PCN-20190829 TEB0724-02 Under Voltage Protection Change

Company	Trenz Electronic GmbH
PCN Number	PCN-20190829
Title	TEB0724-02 Under Voltage Protection Change
Subject	Trenz Electronic TEB0724 Hardware Change
Issue Date	2019-09-05

affected product
TEB0724-02

#1 Replaced R40 by 953kOhm and R44 by 147kOhm

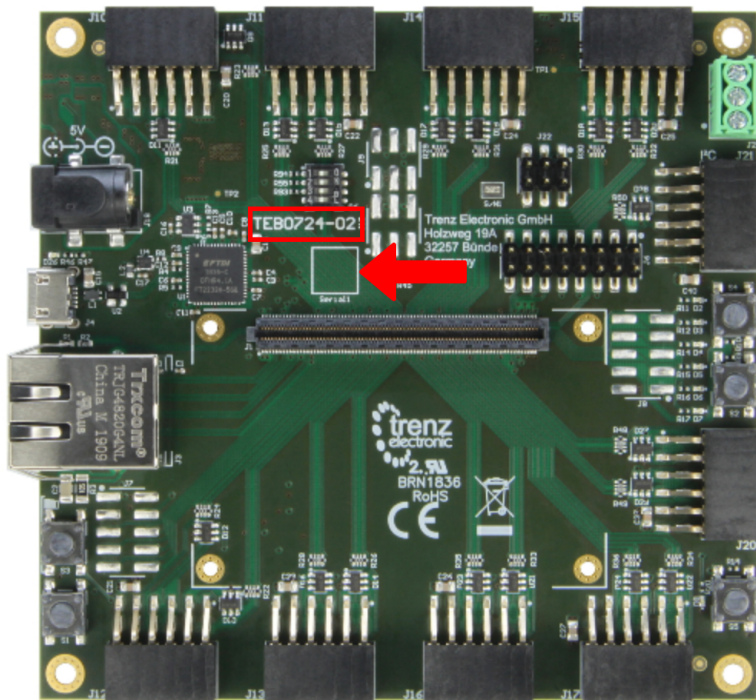
Reason: Large start up currents led due to adverse conditions (e.g. weak powersupply, long wires, increased contact resistance) to a voltage drop below the under voltage lock out limit of the input protection circuit.

Impact: Under voltage protection limit is decreased to 4.06V, which gives a larger margin for a voltage drop during start up.
